## Value Analysis Study October 22 - 24, 2019

## Tamiami Trail Modifications: Next Steps Phase 2

PMIS Number: 259050

## Value Analysis Final Report

**Figure 6: Typical Road Section Developed in Value Analysis**

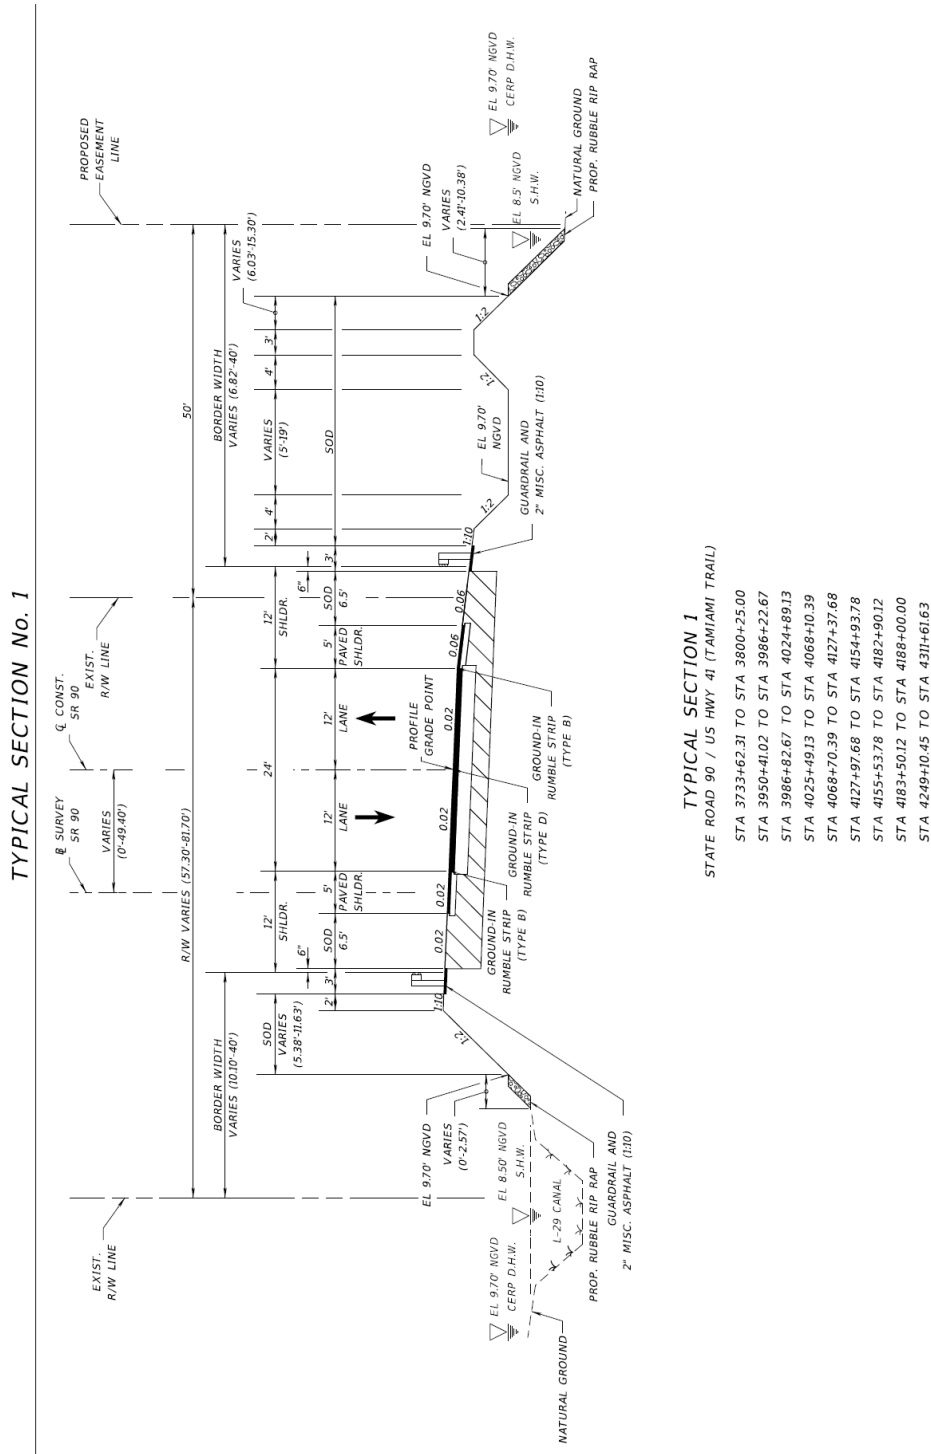
See **Figure 6** for the typical road section developed as part of this value analysis.

### Alternative 4 Florida Slab Beam Bridge

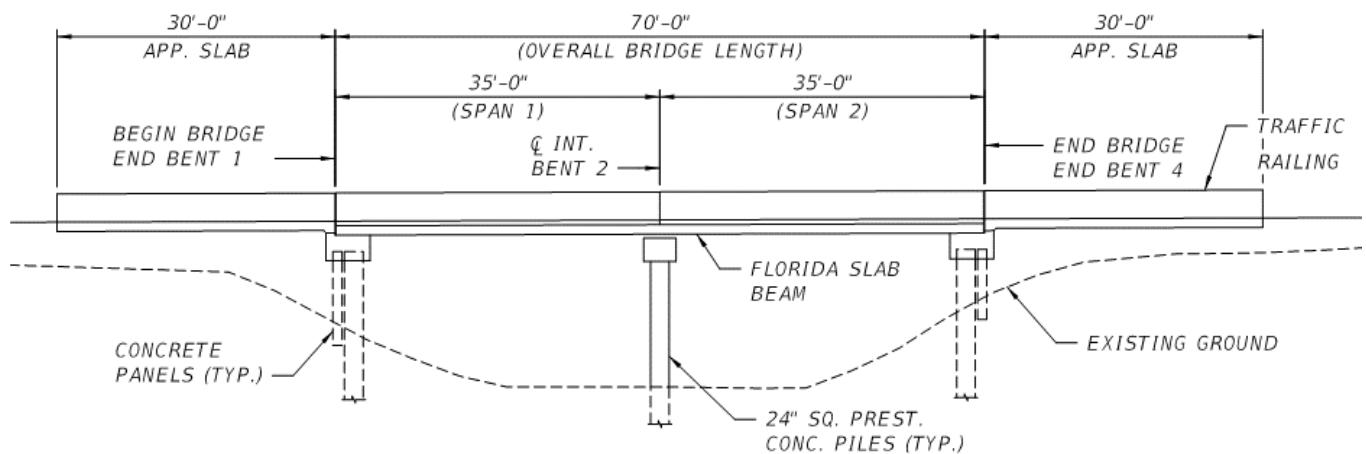
Discussion followed the CBA evaluation of the alternatives. Although Alternative 4, use of Florida slab beam bridge design, scored the best, ideas from the other alternatives and ideas from the creative phase were also of interest. See idea listing in **Section B** of this report.

Alternative 4, Florida slab beam bridge design, received consensus from the VA team as the preferred structural type alternative.

19. Provide draft permit application to DEP for review. *(response: need to do this by end of November)*
20. Consider shelf for wildlife to cross under bridge(s) See bridge design Alternate 4. *(response: this is now incorporated into the design criteria)*

Alternative 1A: Swales, with infiltration trench (every 500 feet)

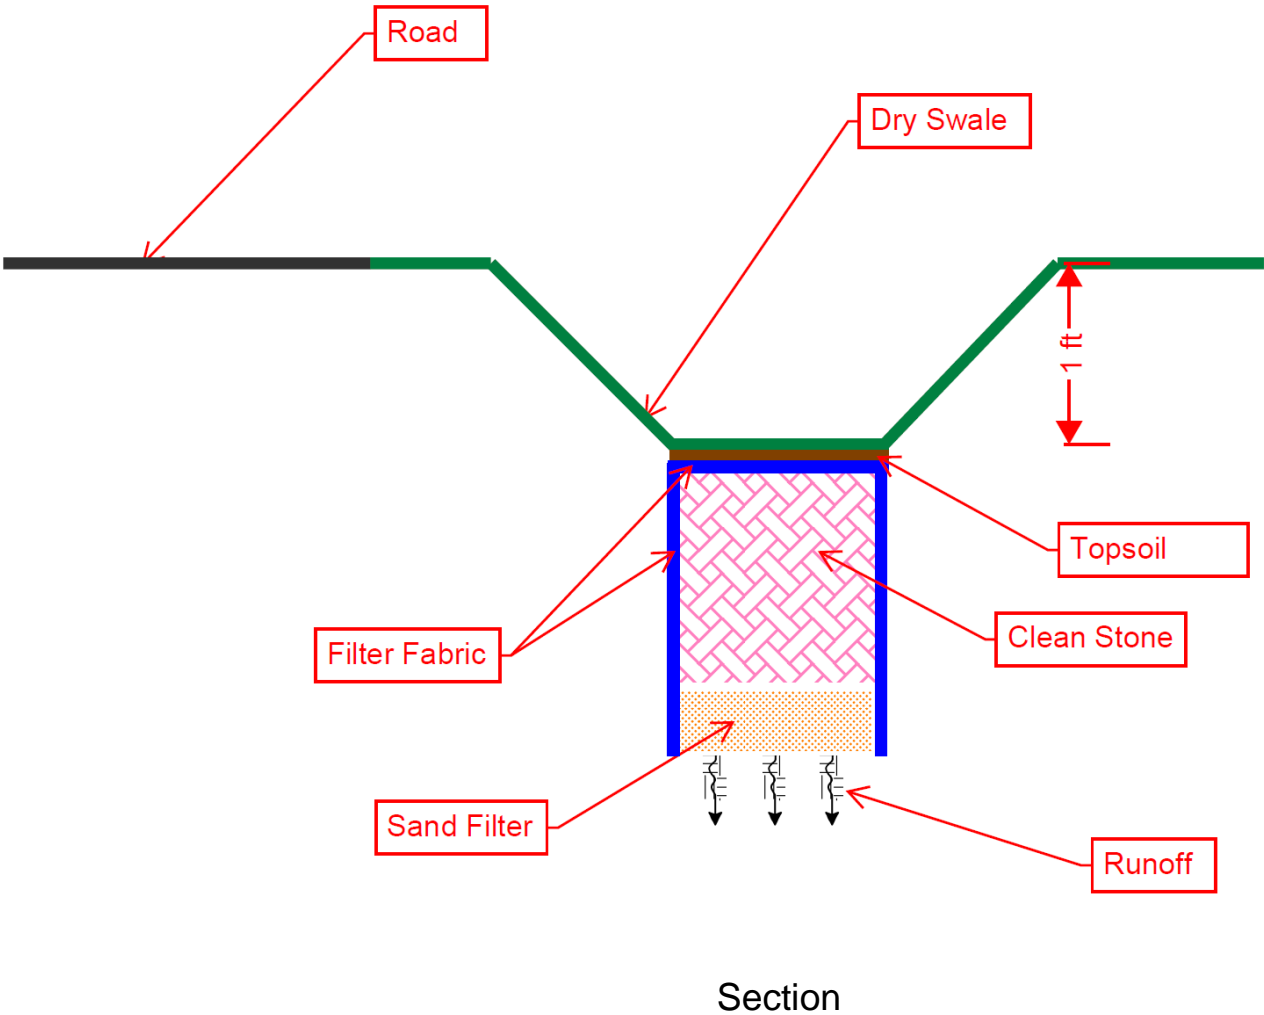
Discussion followed the CBA evaluation of the alternatives. Although stormwater management Alternative 1A, Swales with infiltration trench (every 500 feet), scored the best, ideas from the other alternatives and ideas from the creative phase were also of interest. See idea listing in **Section B** of this report.

Alternative 1A, Swales with infiltration trench (every 500 feet), received consensus from the VA team as the preferred stormwater management alternative.

26. For selected areas use drain structure and pipe to drain to culverts. *(response: not required)*
27. Stormwater Management Alternative 1A – Infiltration trench and de-muck to have volume for swale for extra 50% @ 500-foot intervals. *(response: preferred alternative in CBA, received highest scoring)*
